Certification Submittal for Final Building Certificate of Occupancy for

Ray Cravey Lease Bldg, [C-16 / D006KK]

TRAFFIC CERTIFICATION

RE: RAY CRAVEY LEASE BUILDING 8504 CALLE ALAMEDA N.E. (C16-D6KK)

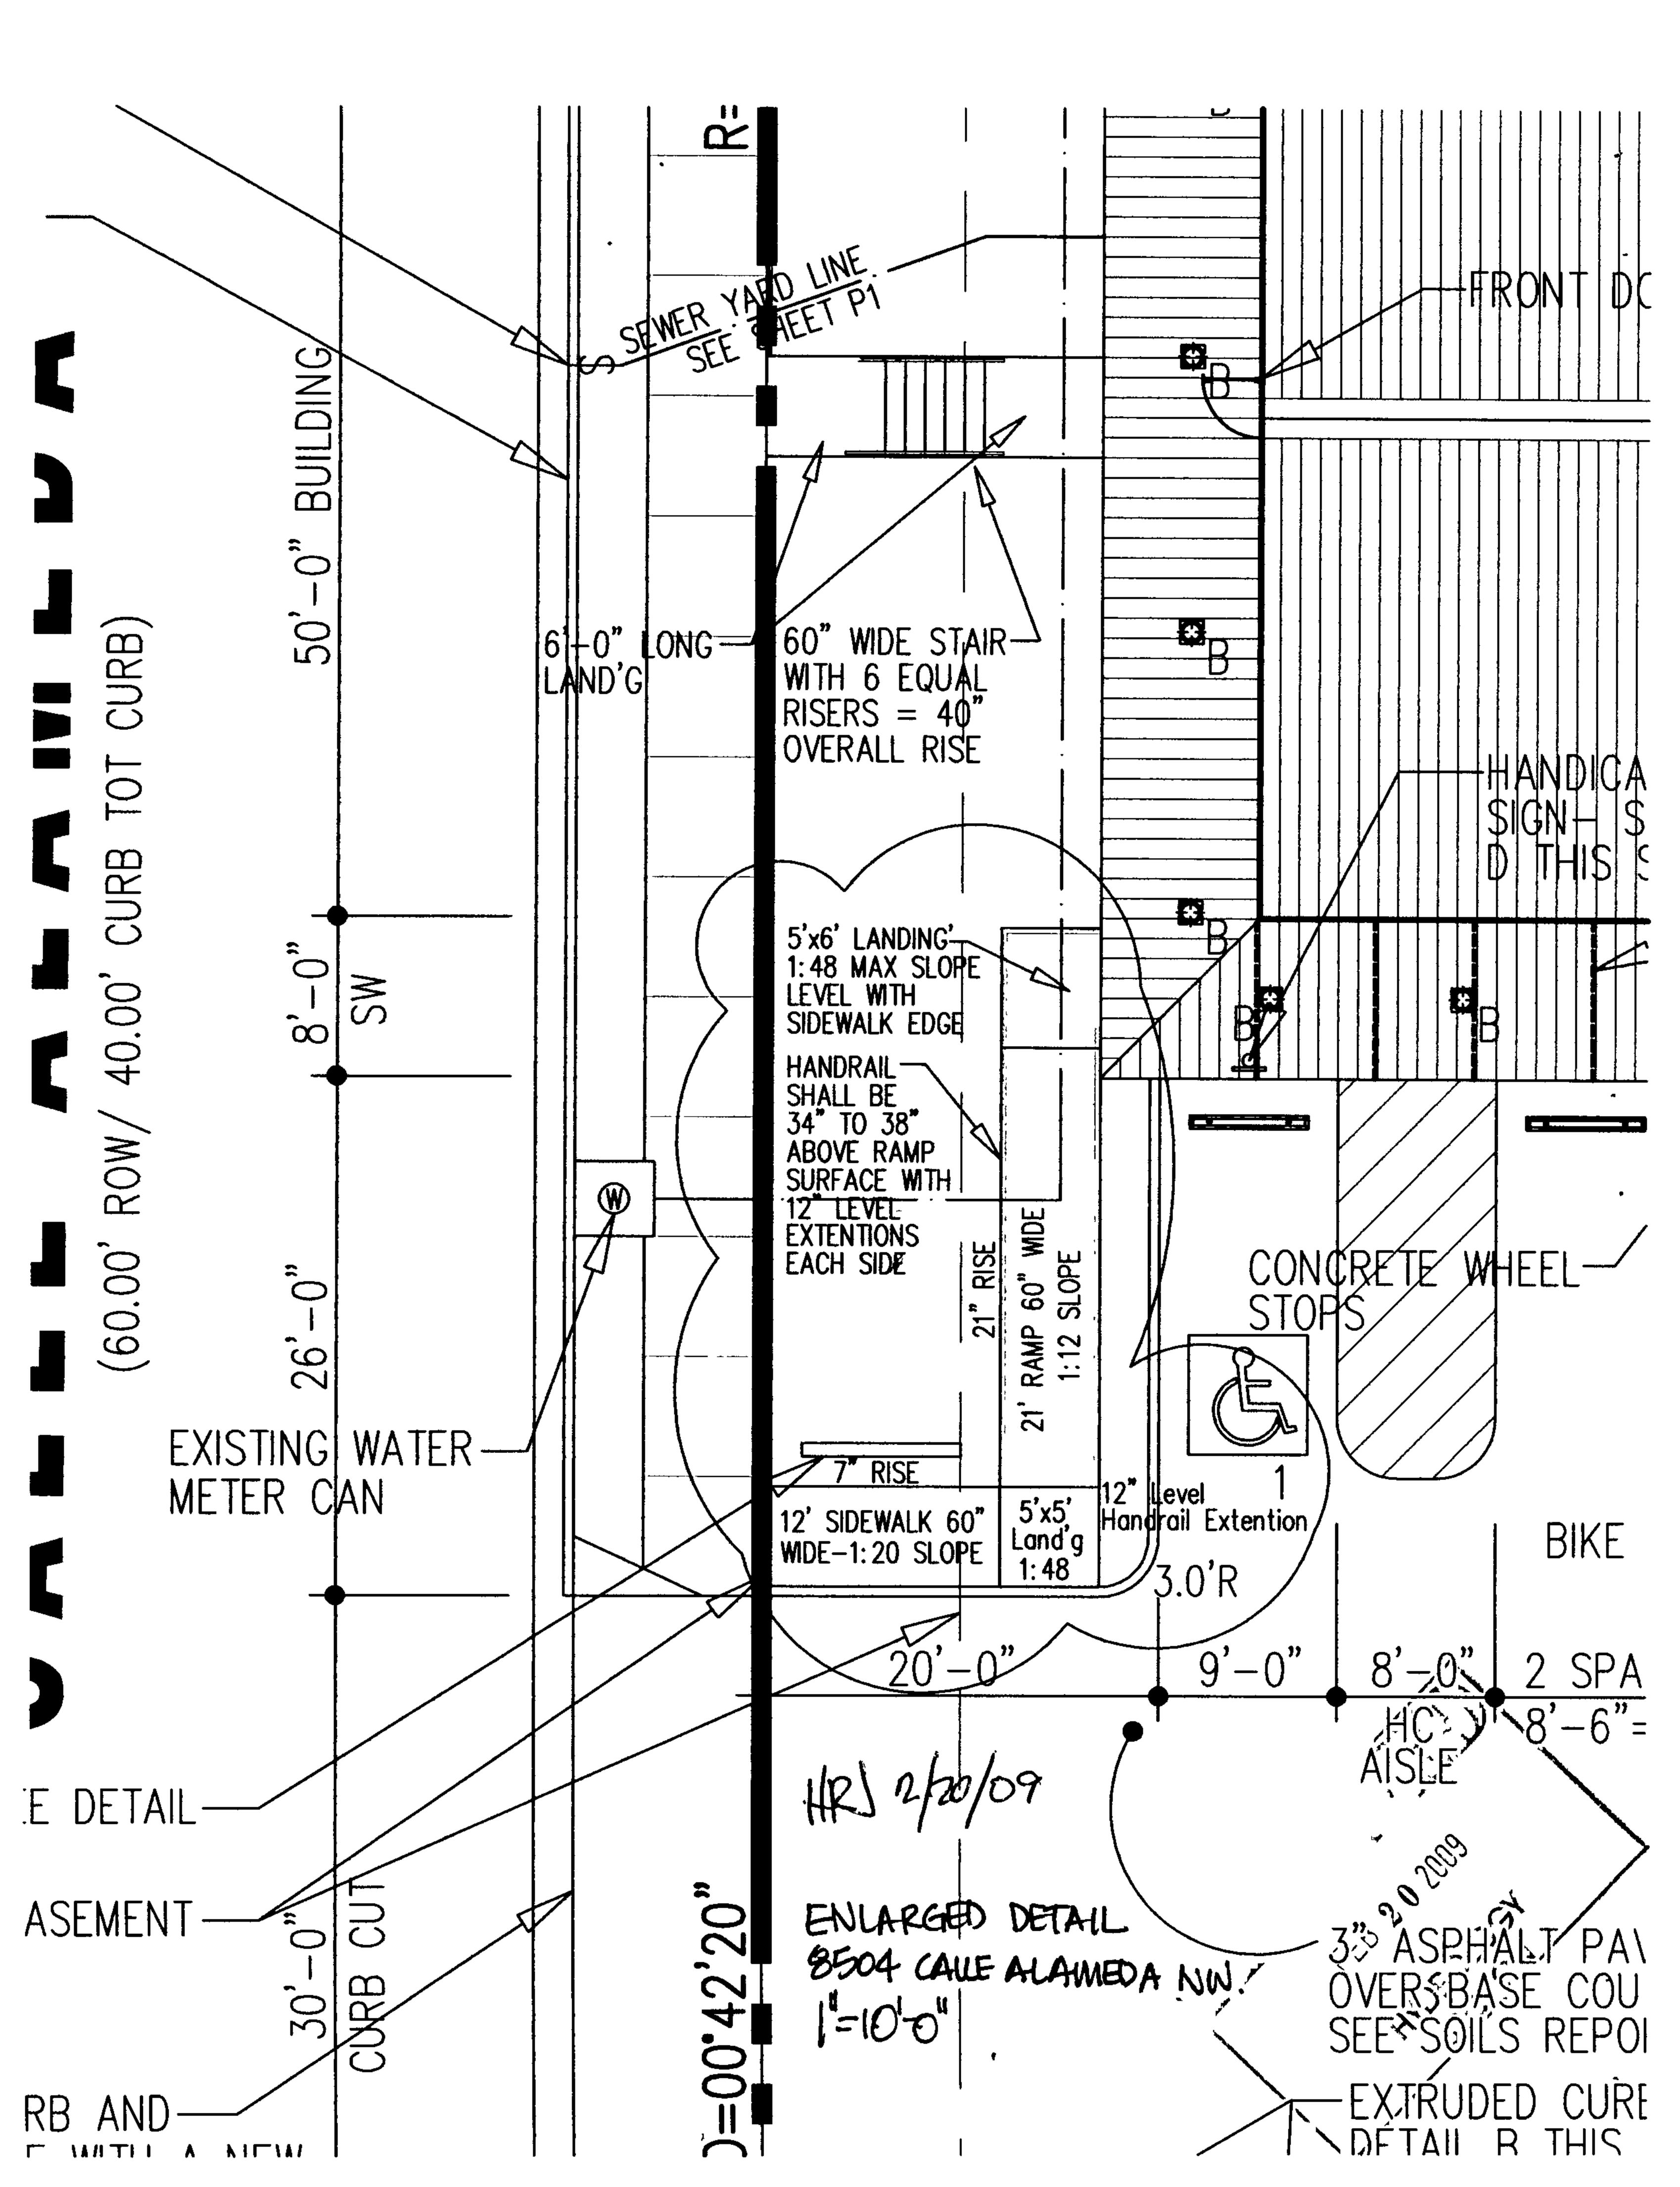
- Dirt area on the east side of building was in-filled with a concrete slab.
- 48" concrete drive apron on south side of building extended.
- Relocated 6' wide private walk from public sidewalk to building; to a 5' wide with 6 steps at main entry doors.
- Addition of handicap ramp adjacent to drive entry from public access to facility entrance.
